STAFF RECOMMENDATION 904 Bradford Avenue August 17, 2016

Application: New construction—detached accessory dwelling unit; Setback determination

District: Waverly-Belmont Neighborhood Conservation Zoning Overlay

Description of Project: Application is to construct a detached accessory dwelling unit (DADU) at the rear of the lot. The structure requires a rear setback determination from twenty feet (20') to ten feet (10').

1 FRONT ELEVATION
 SCALE 1/4" = 1'-0"

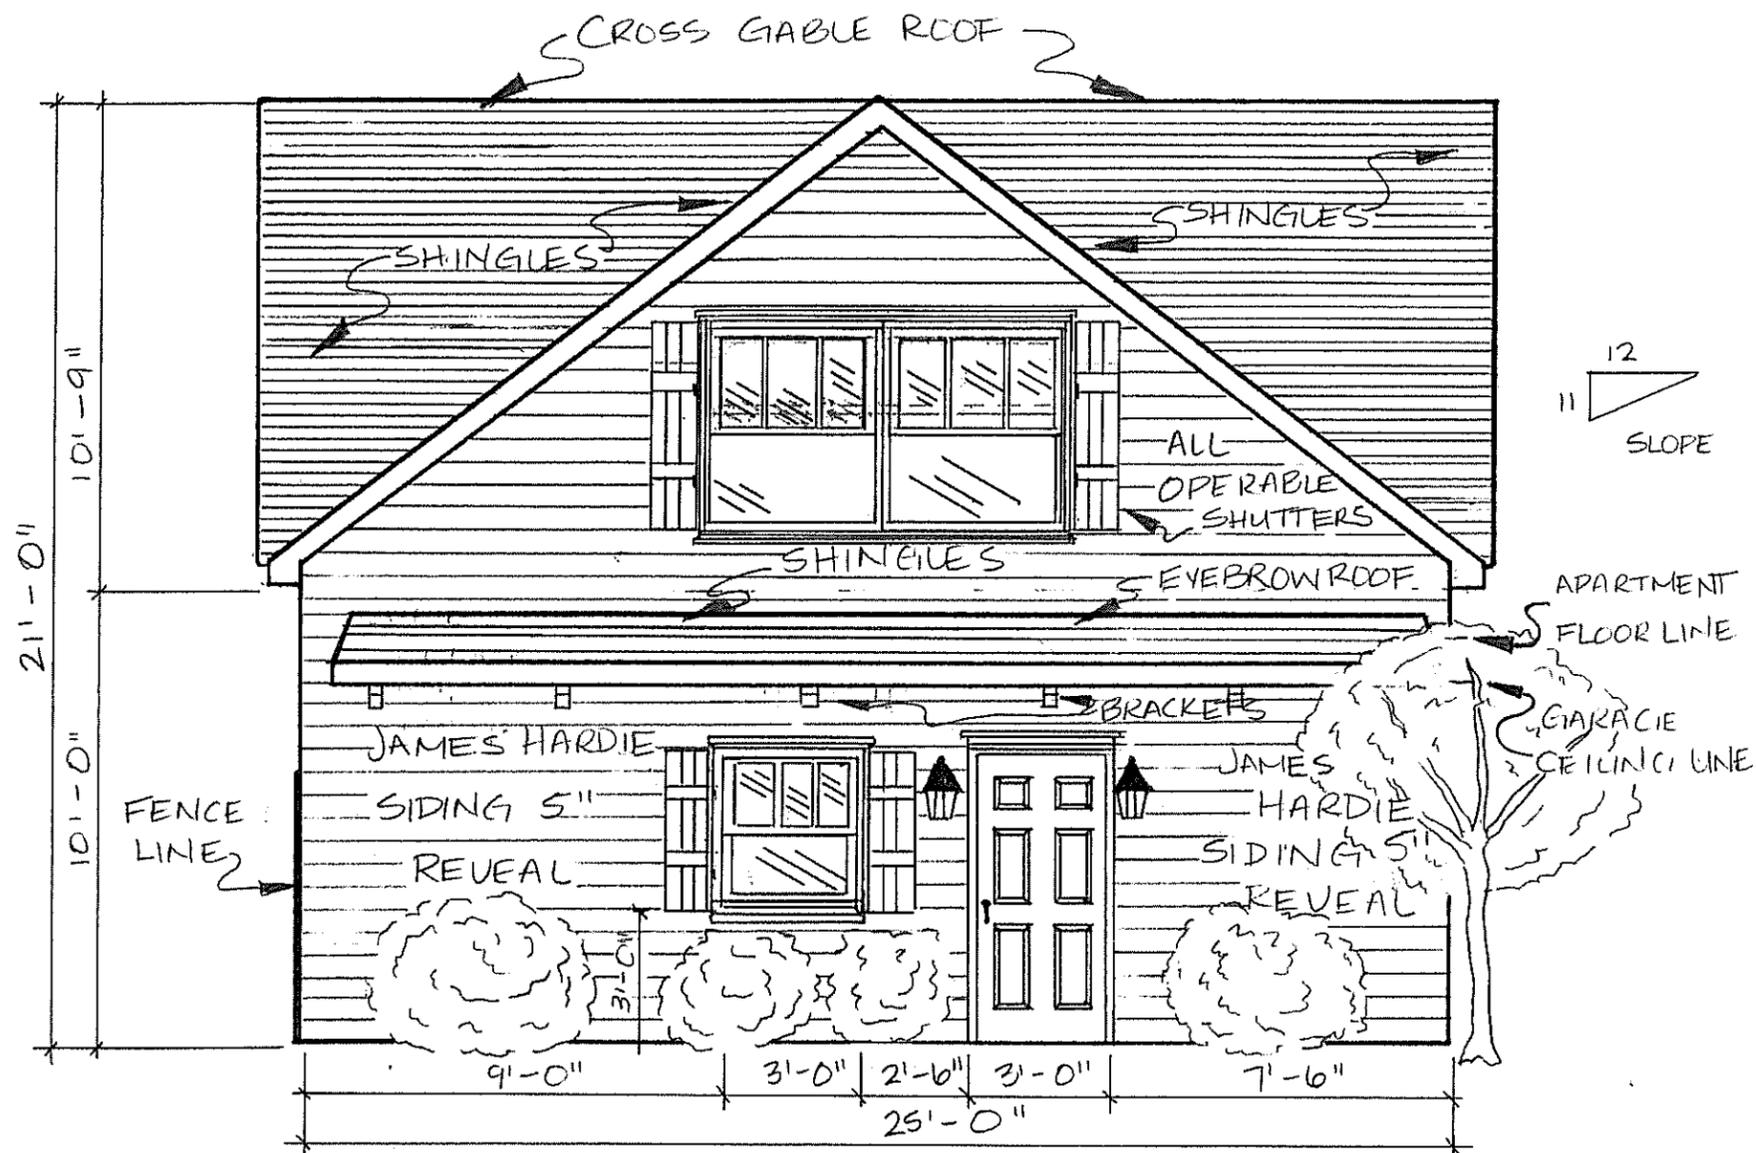
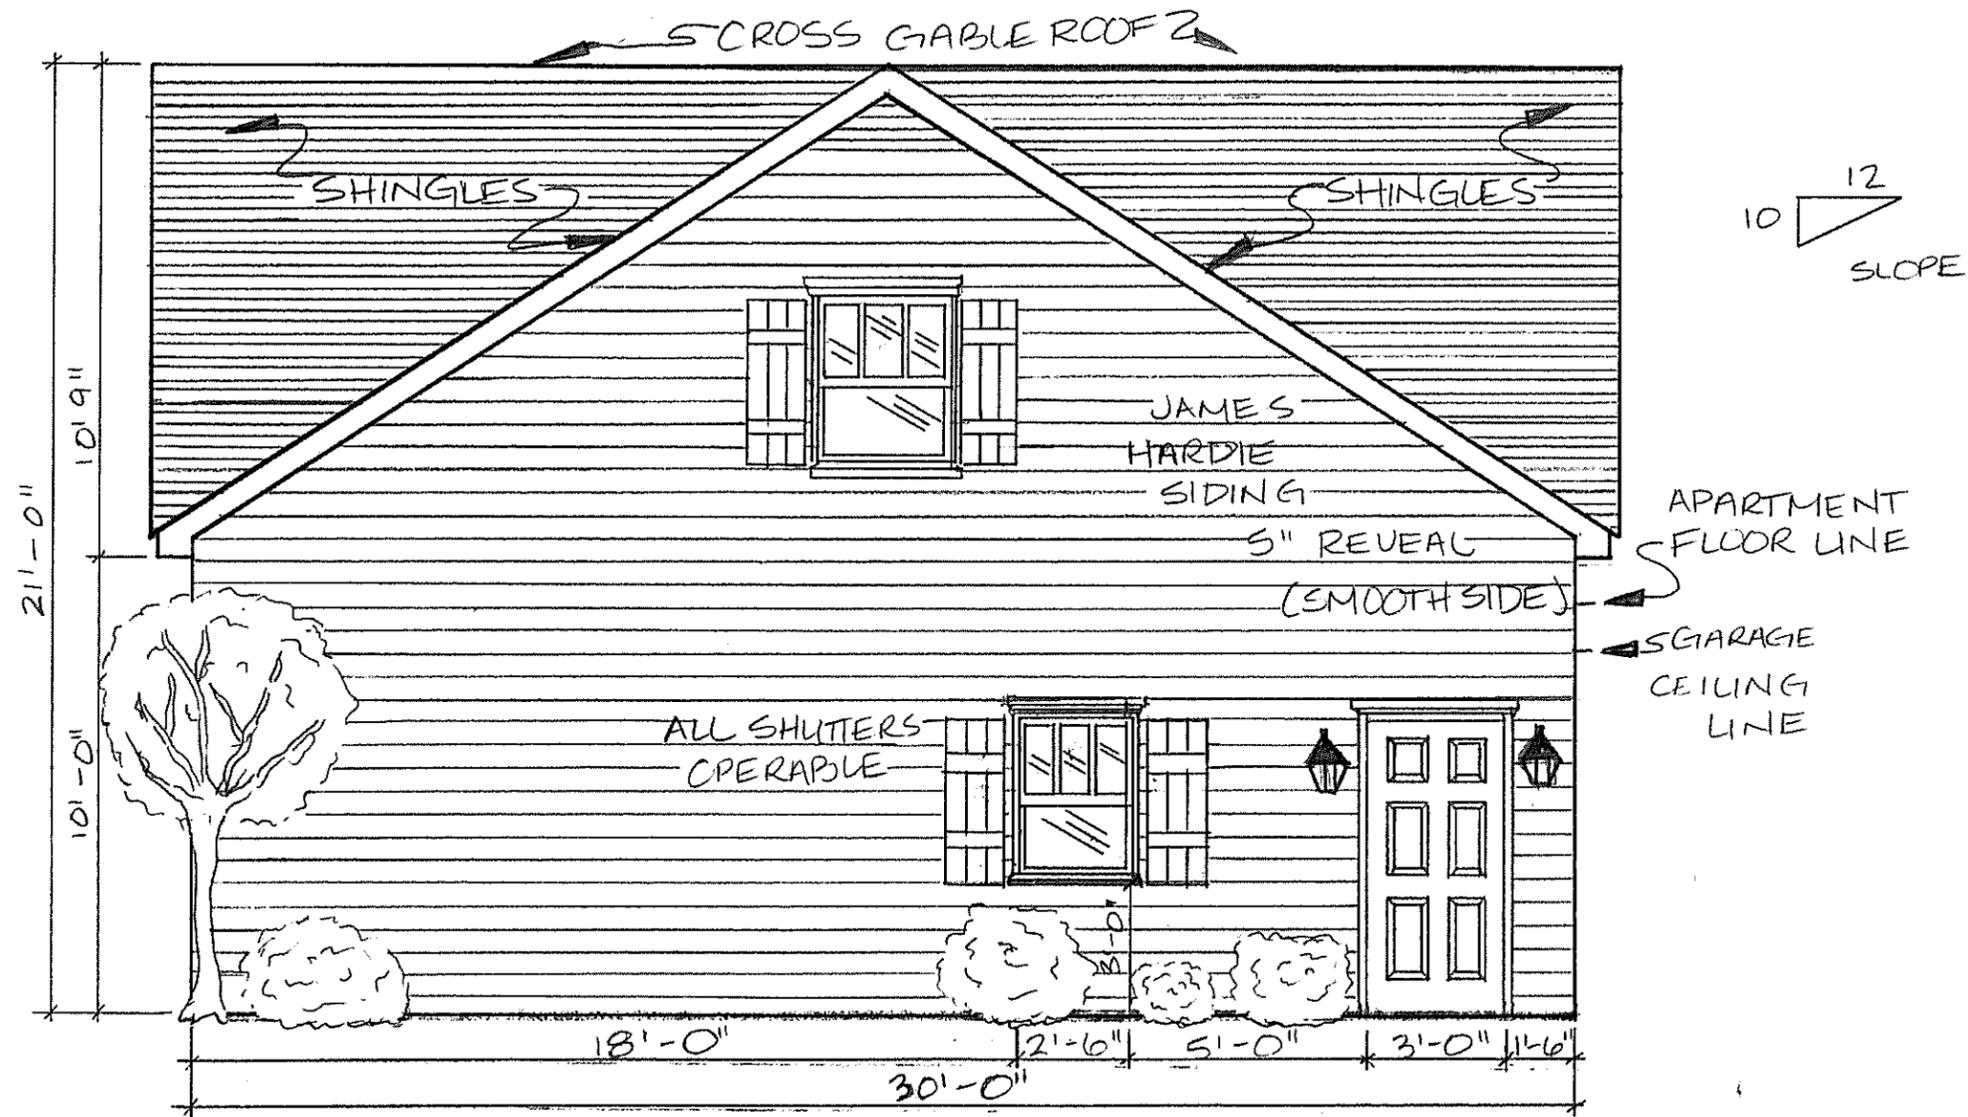
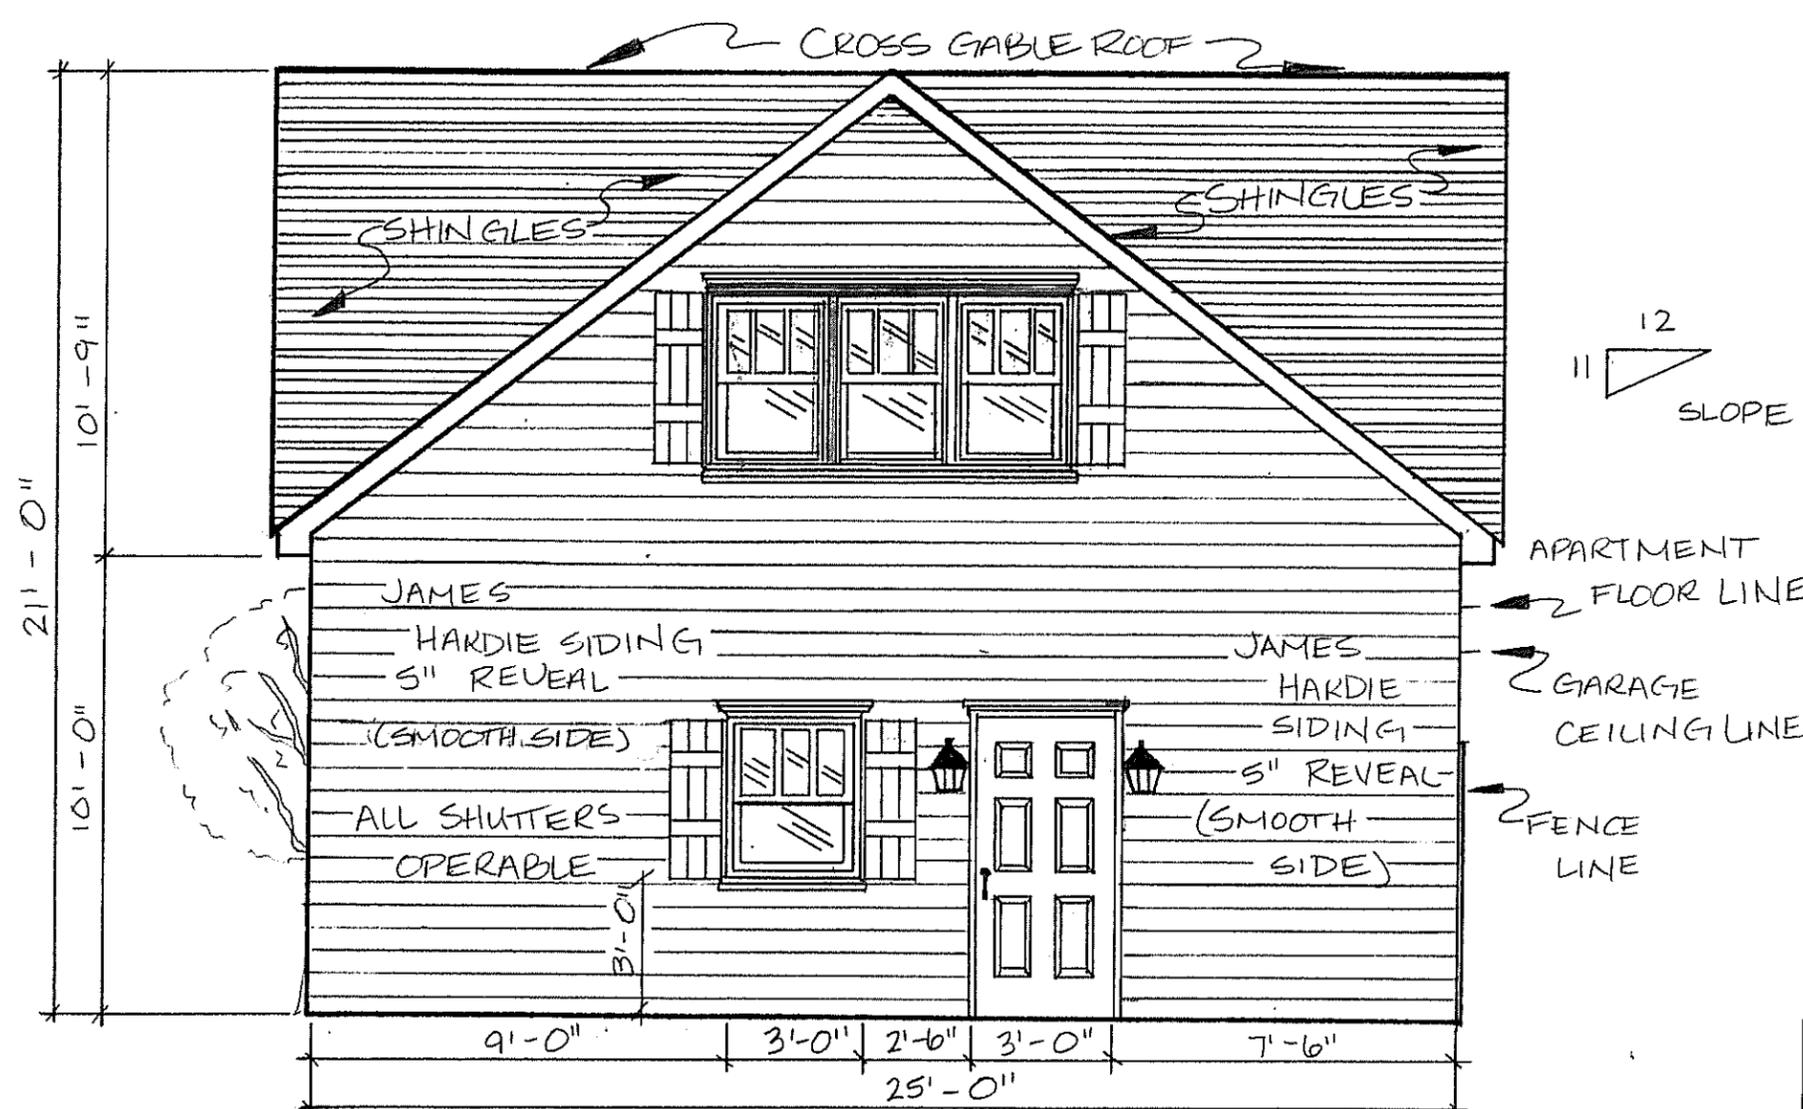
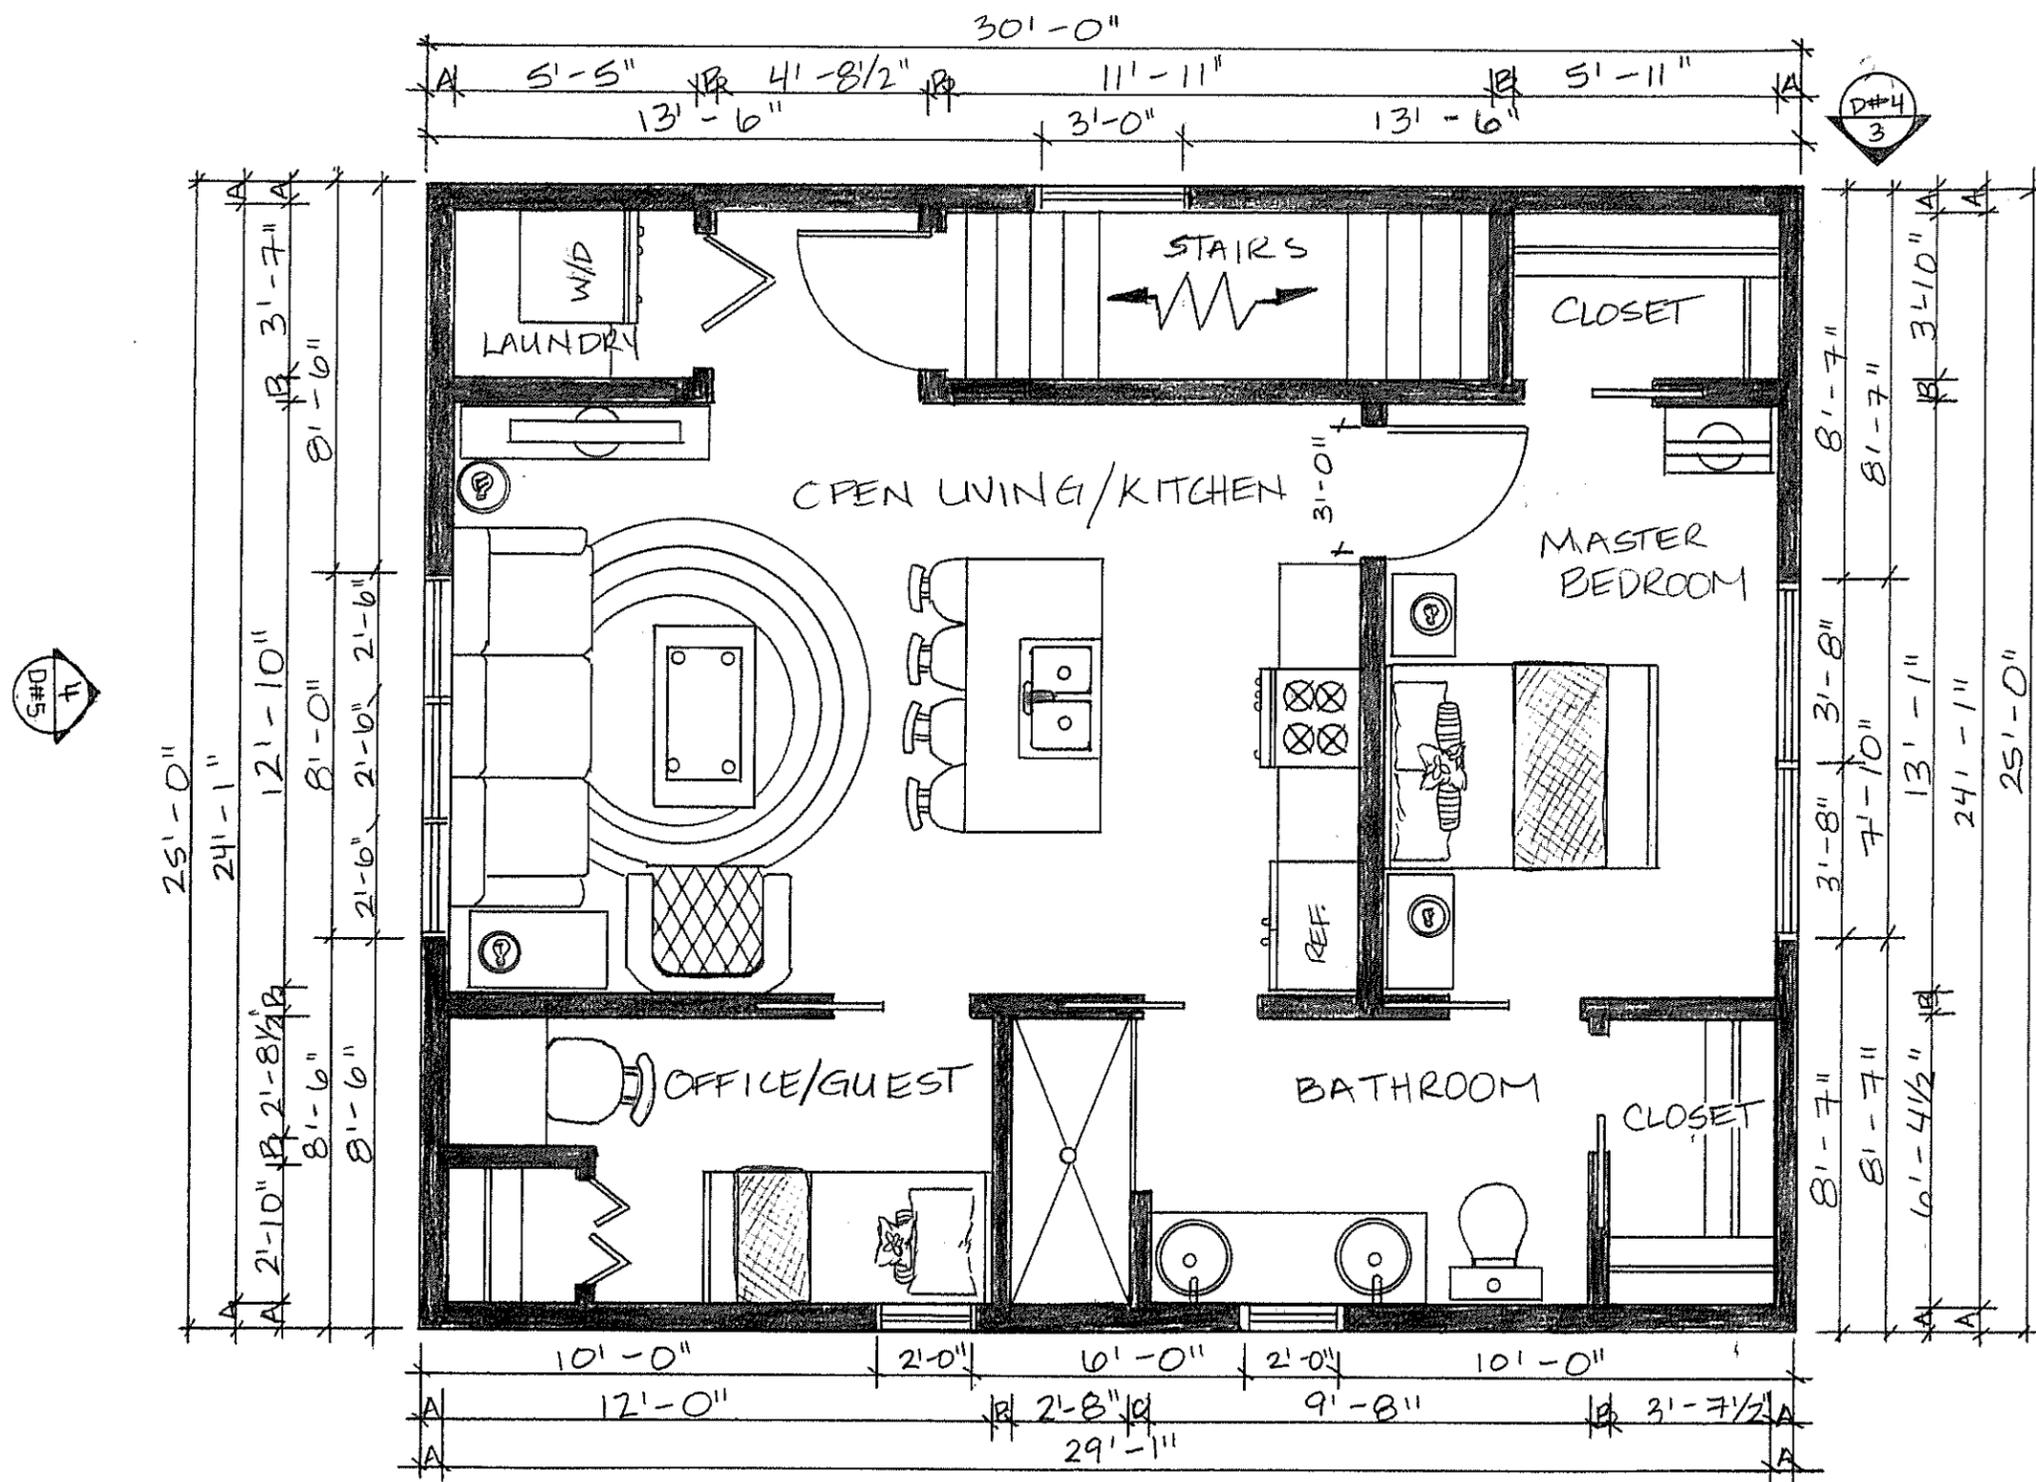
Design Standards: The accessory structure has a simple, utilitarian design that is appropriate for outbuildings. Its roof form, detailing, and form do not contrast greatly with the primary structure. The DADU is in a minimally-visible location at rear of the lot. Four inch (4") wood casings were not shown around windows and doors, and staff recommends that all windows and doors have nominal four inch (4") casings. The double and triple windows in the upper levels on the side elevations lack four to six inch (4"-6") mullions, and staff recommends that all paired and triple window openings have four to six inch (4" – 6") mullions.

With the addition of four inch (4") nominal wood casings around windows and doors, and four to six inch (4"-6") mullions in between double and triple window openings, staff finds that the design meets Section III.H. of the design guidelines and Section 17.16.030.G.8 of the ordinance.
